**FLORIDA DEPARTMENT OF
ENVIRONMENTAL PROTECTION**

RE: Modification of Permit No.: 16-255718-001-ES
Modification No.: 16-255718-004-EM

The requested modification is to:

**JACKSONVILLE HARBOR, FLORIDA
BARTRAM ISLAND CELL A,
SHORE PROTECTION AND WETLAND RESTORATION
CELL A EROSION CONTROL WAVE ATTENUATION STRUCTURE AND HAUL ROAD PLAN**

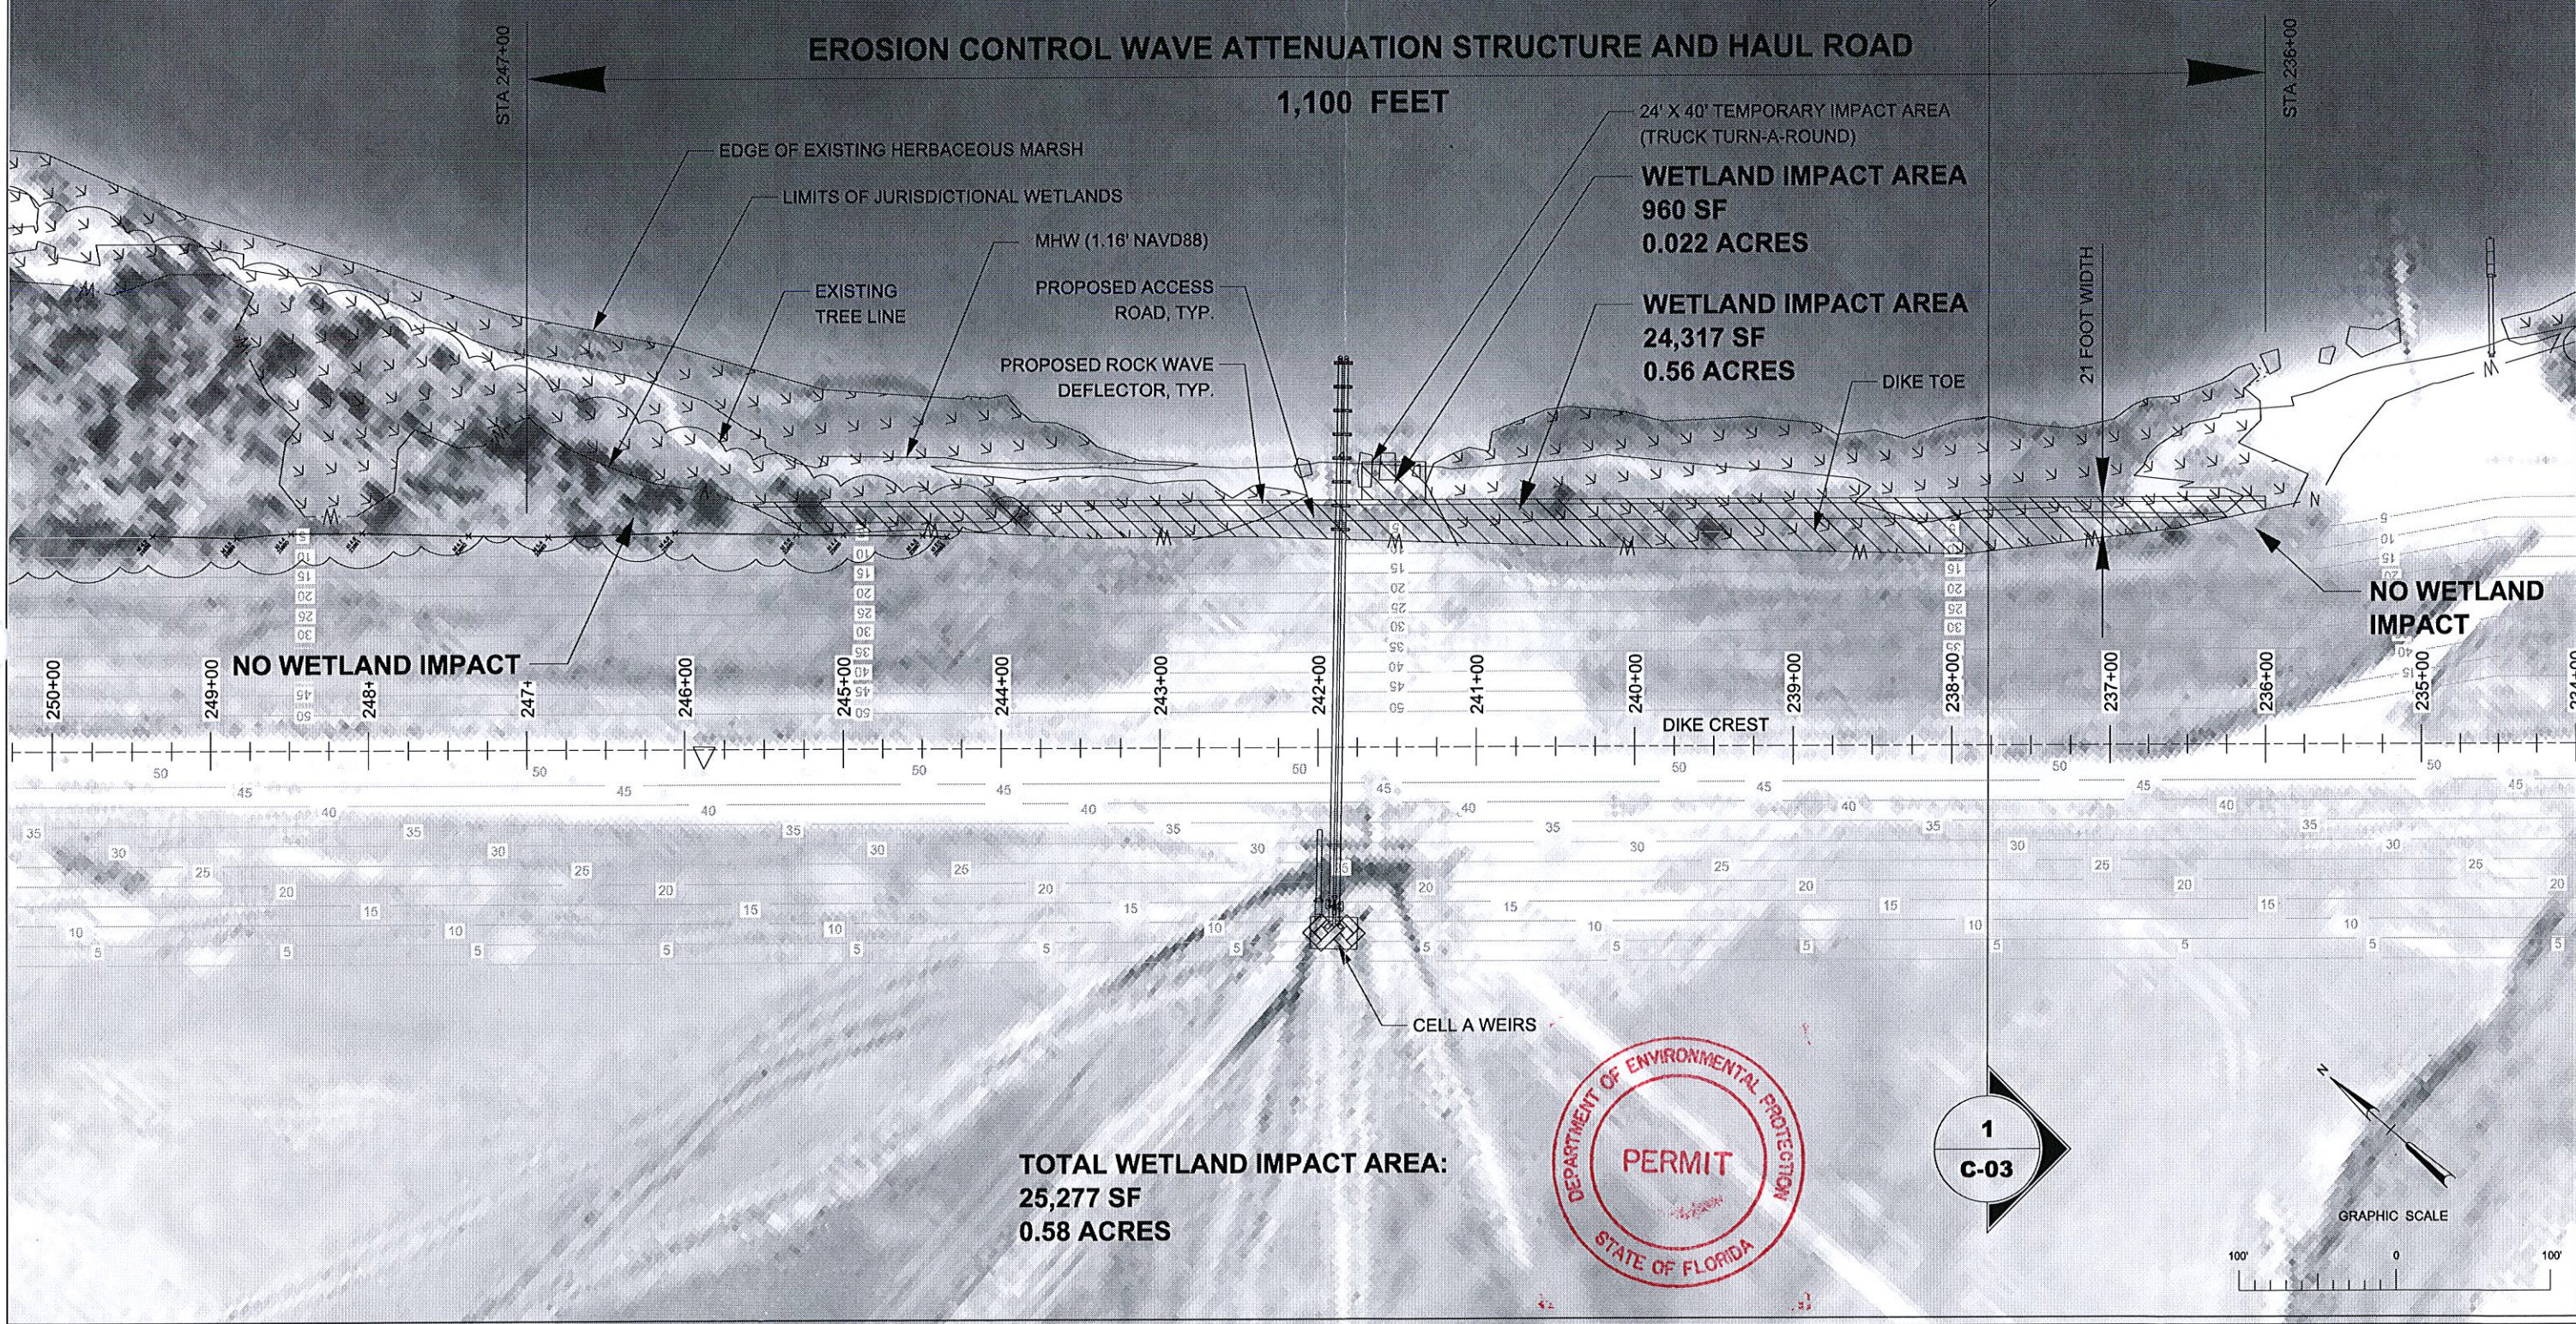
1. Remove the construction of the previously authorized underdrain system in Cell B2 from the scope of work.
2. Add the construction of approximately 1,100 linear feet by approximately 21 feet of wave attenuation structure to the scope of work. The construction will permanently impact approximately 0.58 acres of jurisdictional saltmarsh wetlands at the project site.
3. To mitigate for the functional loss of the impacted wetlands a mitigation area shall be constructed on Bartram Island immediately east of Cell C. In accordance with the Uniform

**AREA OF EROSION CONTROL
WAVE ATTENUATION STRUCTURE
(SEE PLATE C-02)**

JACKSONVILLE HARBOR, FLORIDA
BARTRAM ISLAND CELL A,
SHORE PROTECTION AND WETLAND RESTORATION
WETLAND MITIGATION - PLAN VIEW

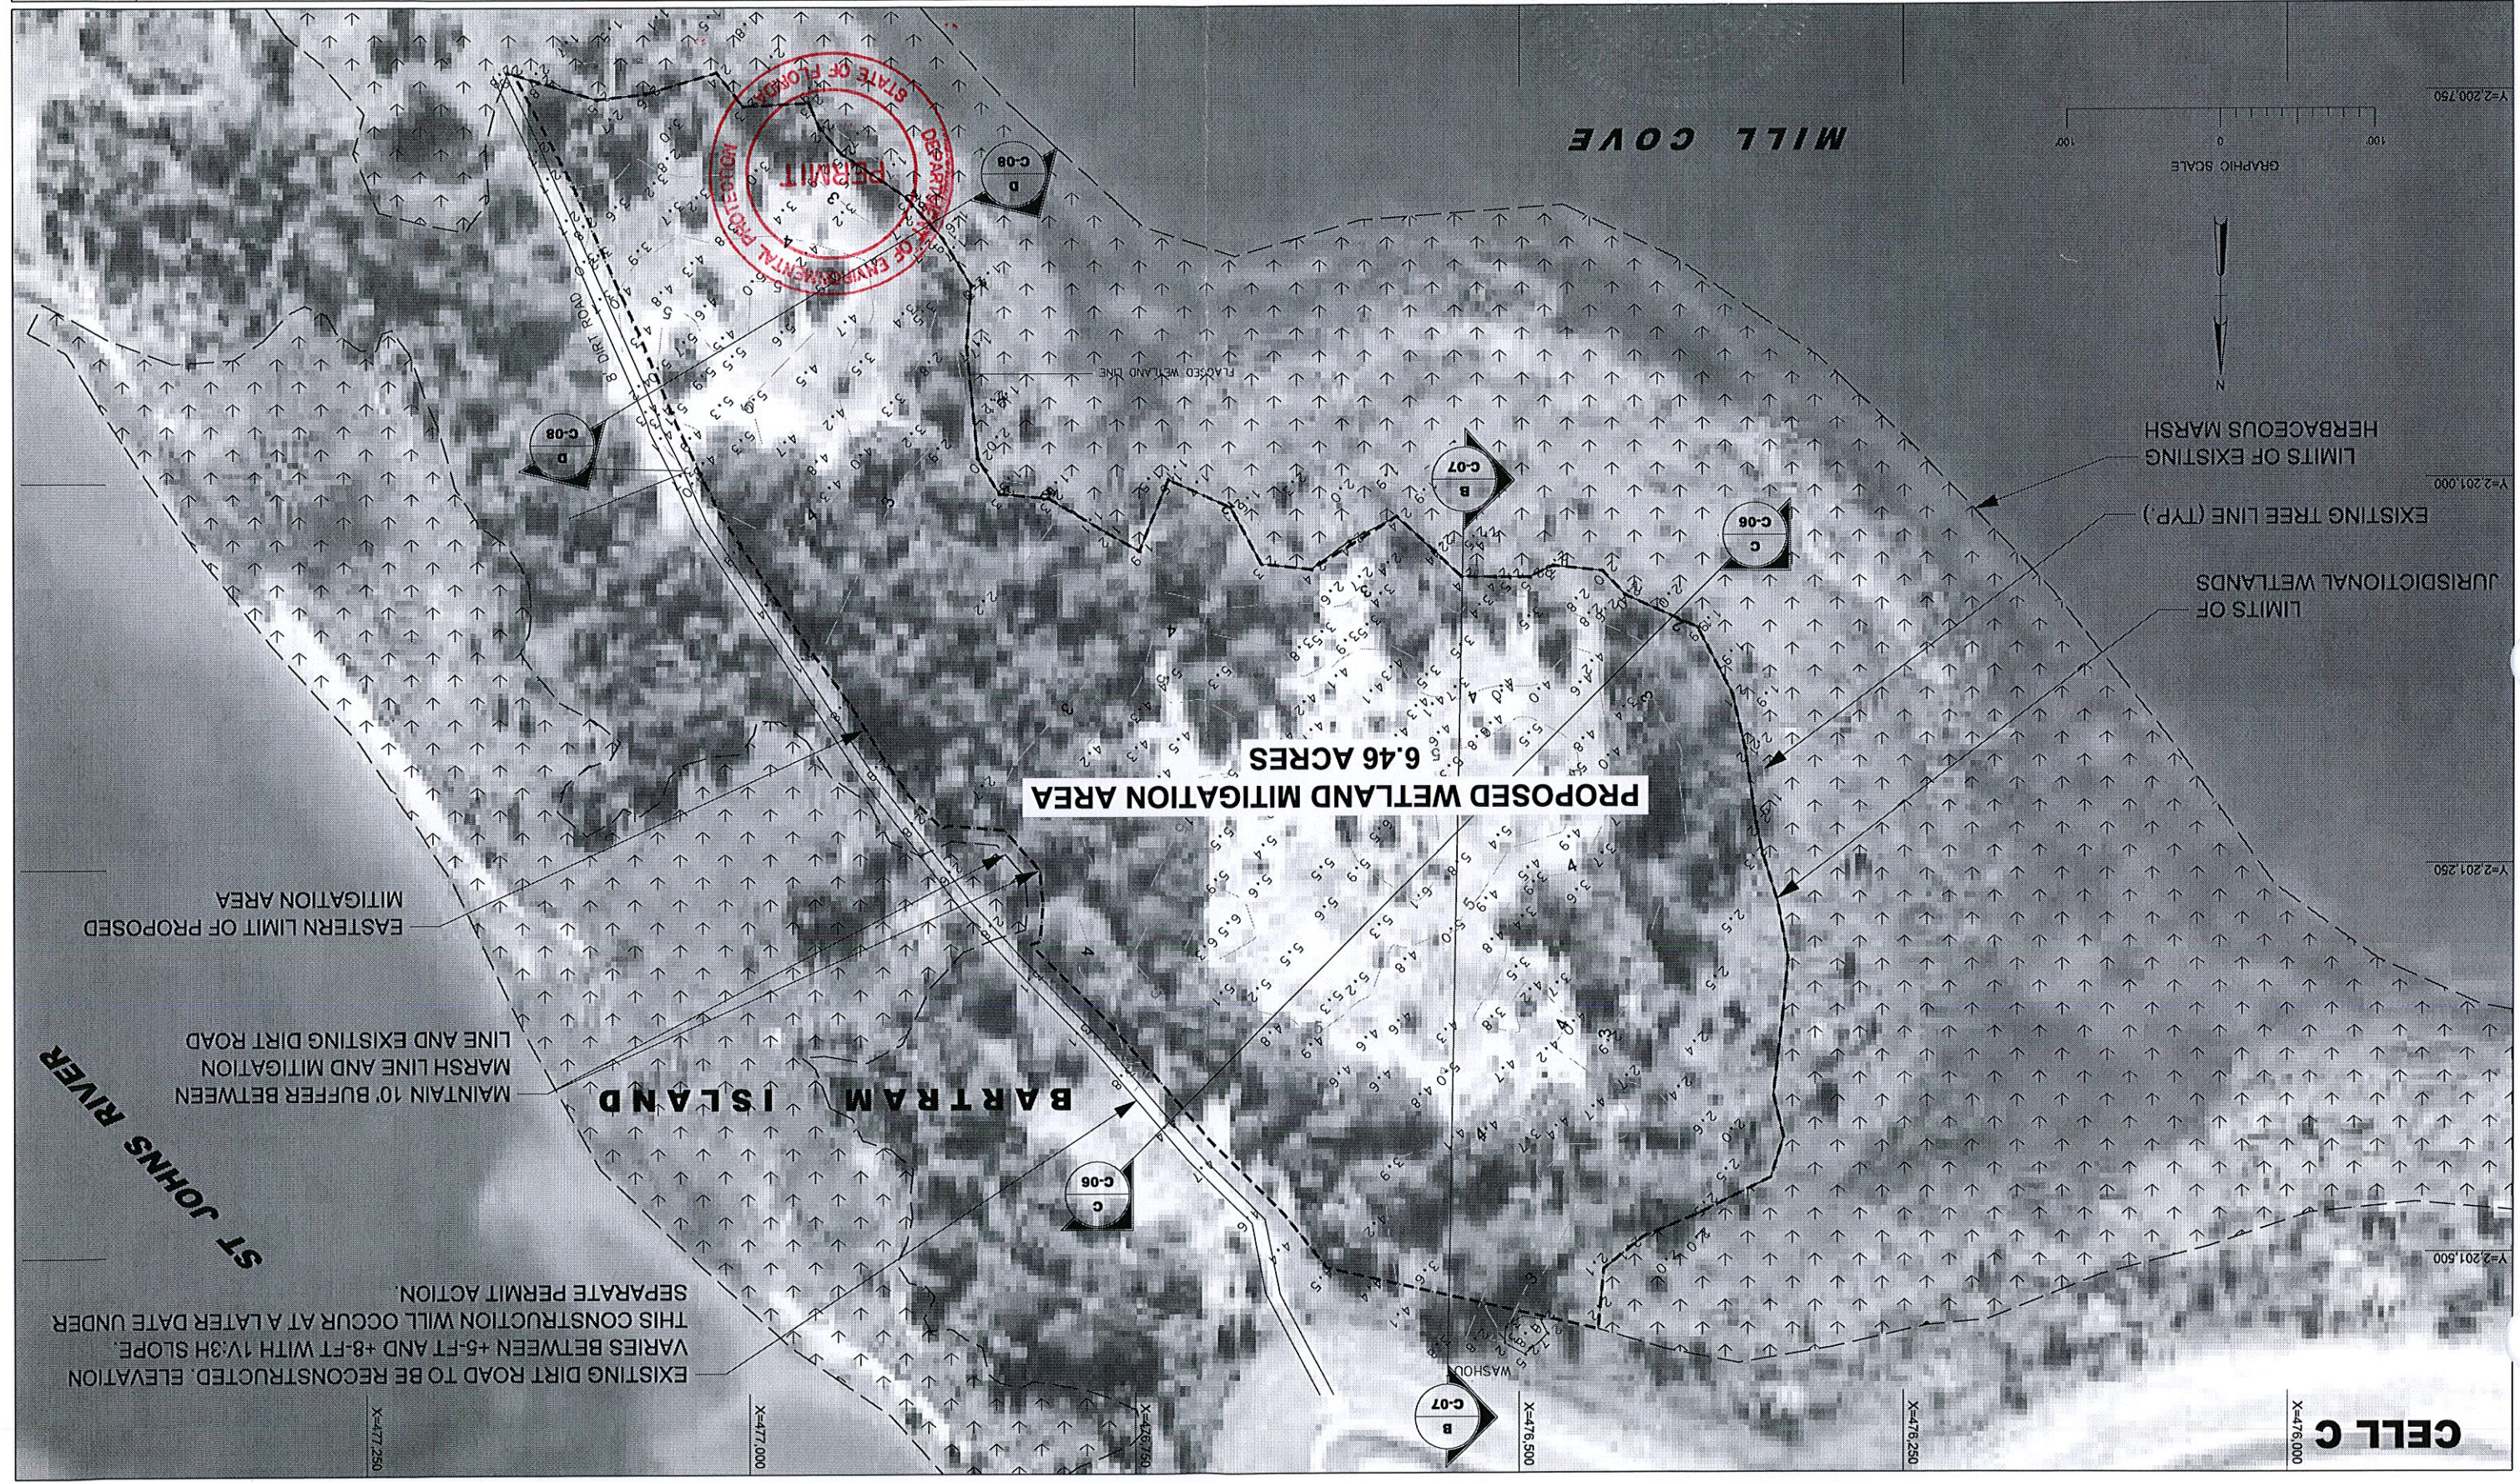
EXISTING DIRT ROAD TO BE RECONSTRUCTED. ELEVATION VARIES BETWEEN +5-FT AND +8-FT WITH 1V:3H SLOPE. THIS CONSTRUCTION WILL OCCUR AT A LATER DATE UNDER SEPARATE PERMIT ACTION.

MAINTAIN 10' BUFFER BETWEEN MARSH LINE AND MITIGATION LINE AND EXISTING DIRT ROAD
EASTERN LIMIT OF PROPOSED MITIGATION AREA

JACKSONVILLE HARBOR
 DUVAL COUNTY, FLORIDA
DMMA BARTRAM ISLAND
CELL A DIKE RAISING
UNDERDRAIN DETAILS

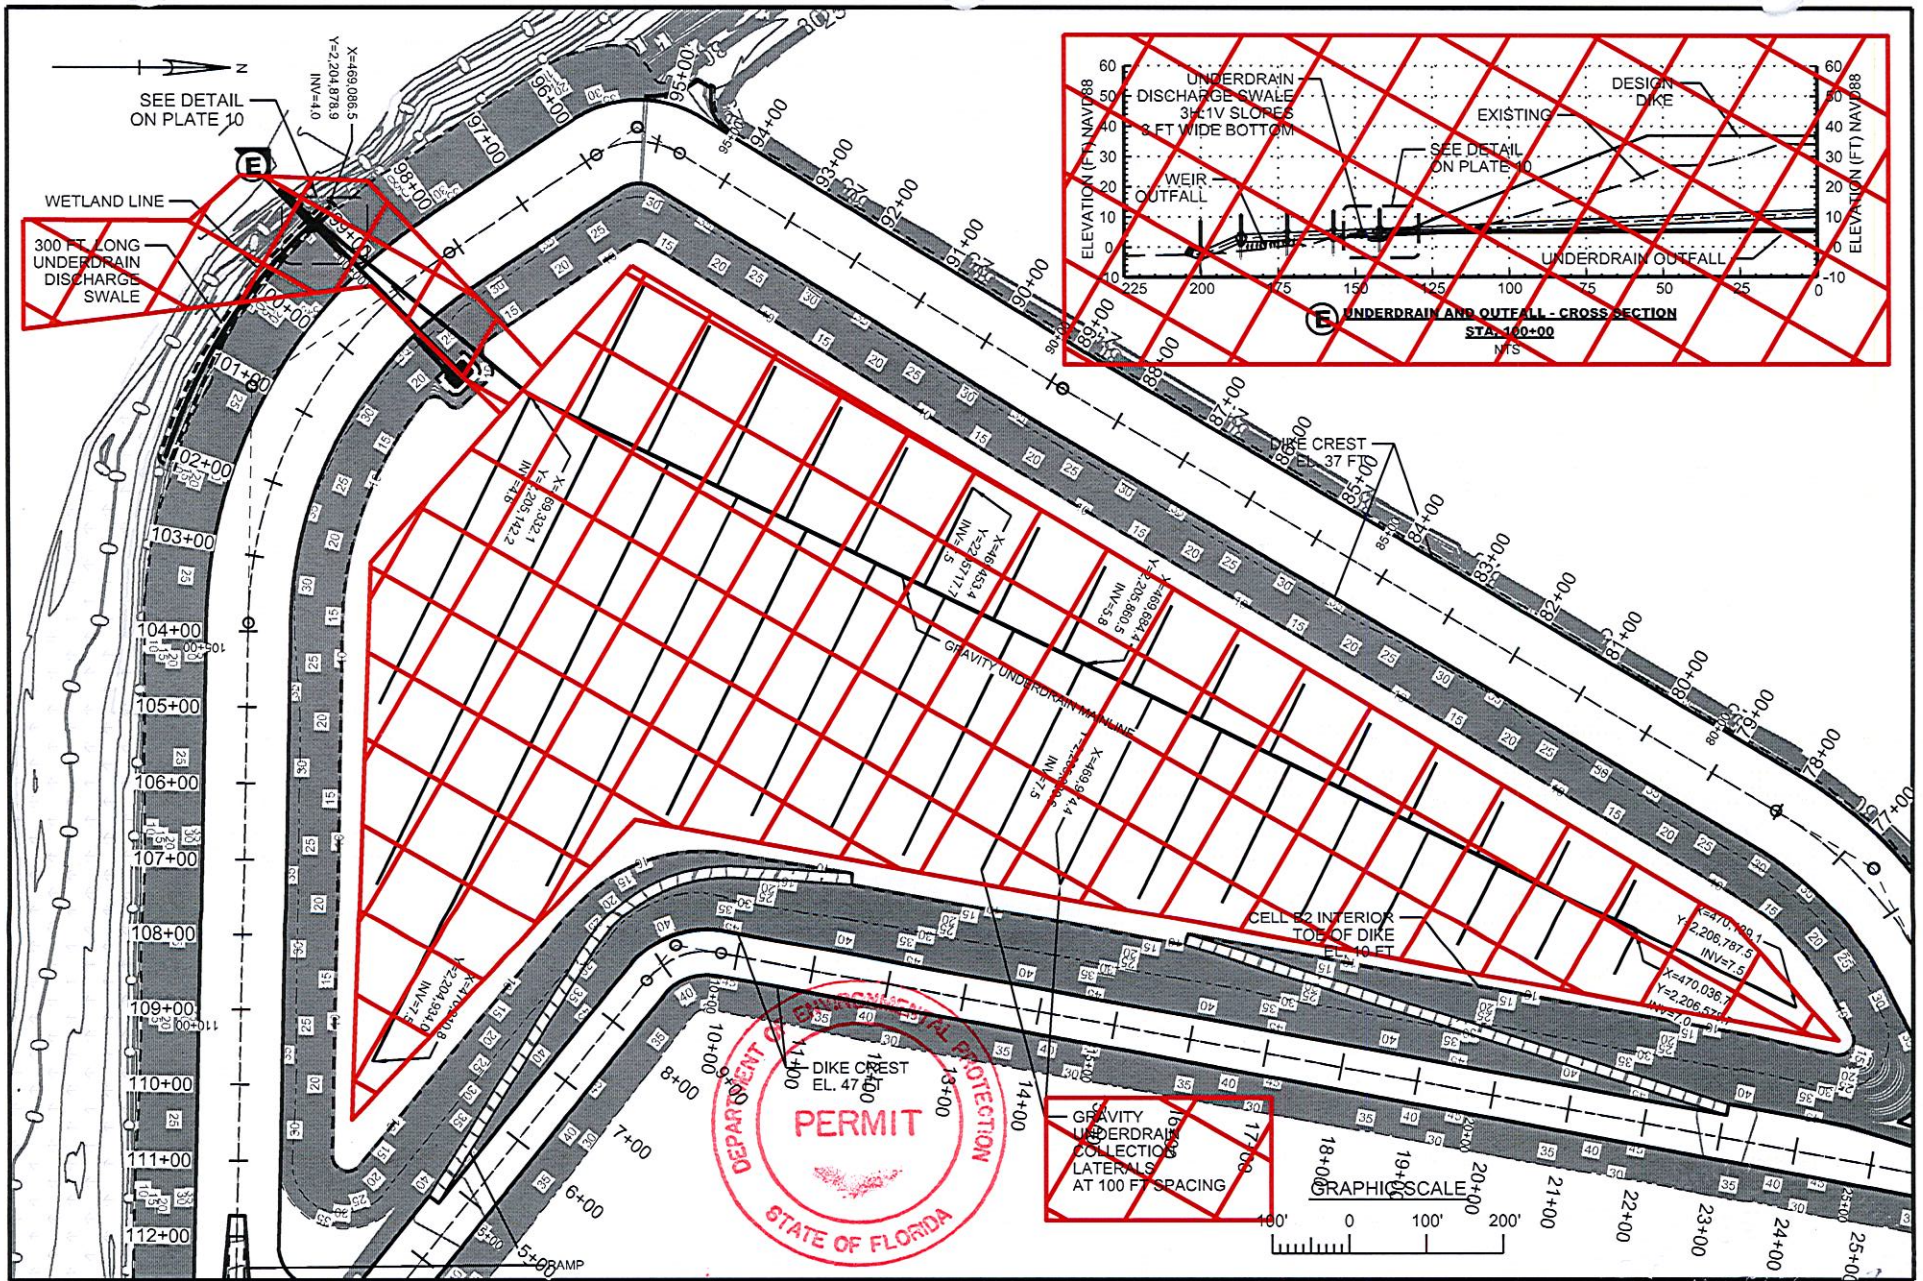
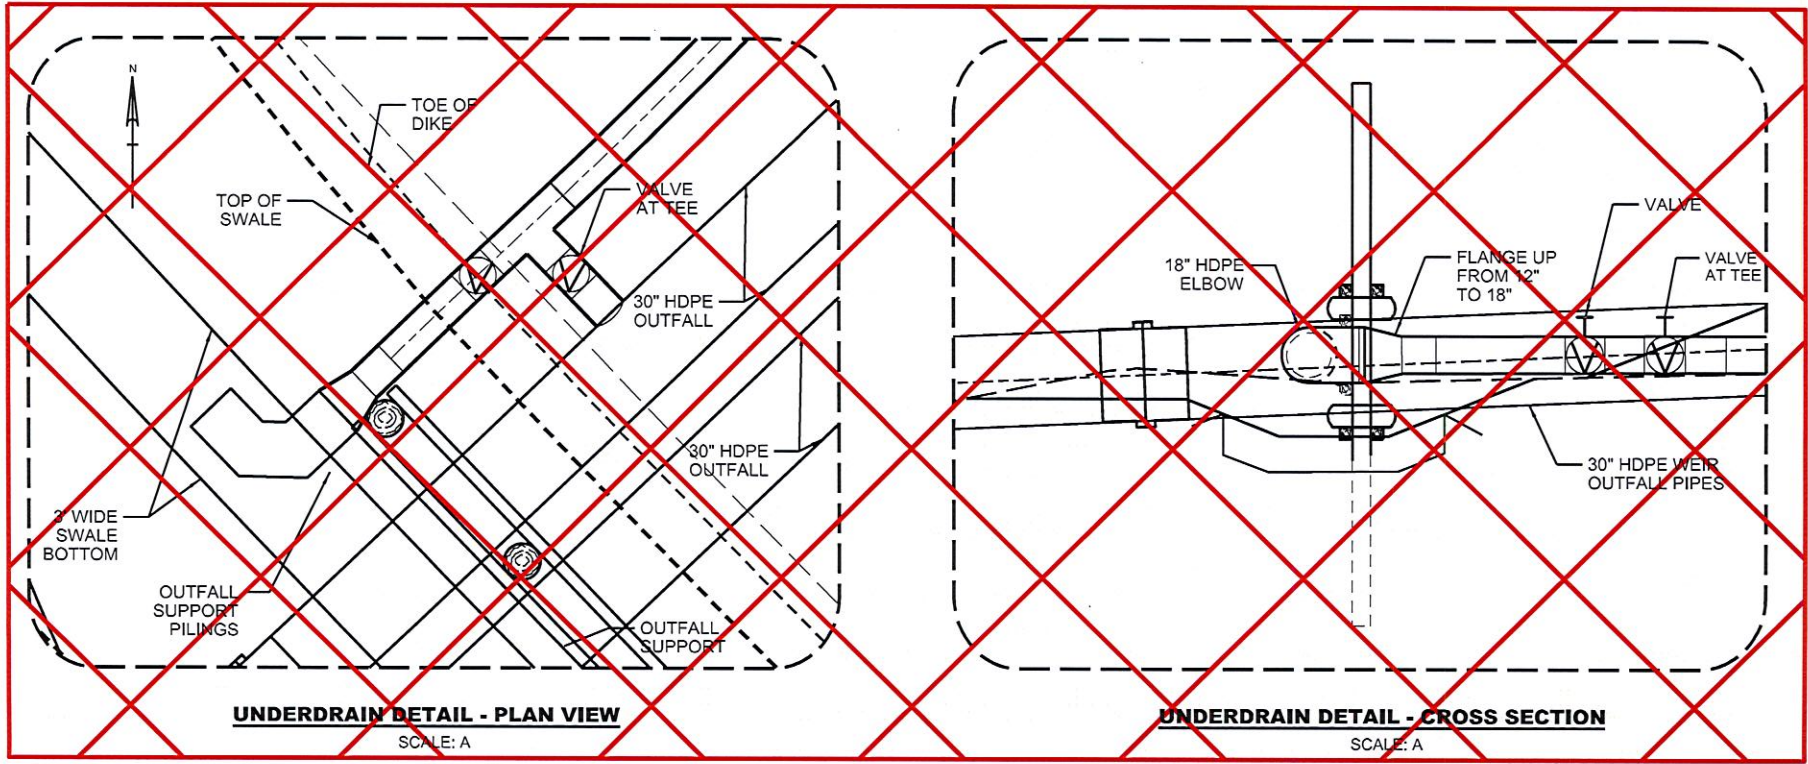
NOTE:
UNDERDRAIN COLLECTION SYSTEM, DISCHARGE OUTFALL, AND 300' RECEIVING SWALE AT EXTERIOR DIKE TOE ARE DELETED FROM CONSTRUCTION PLANS AS OF 29 JULY 2013.
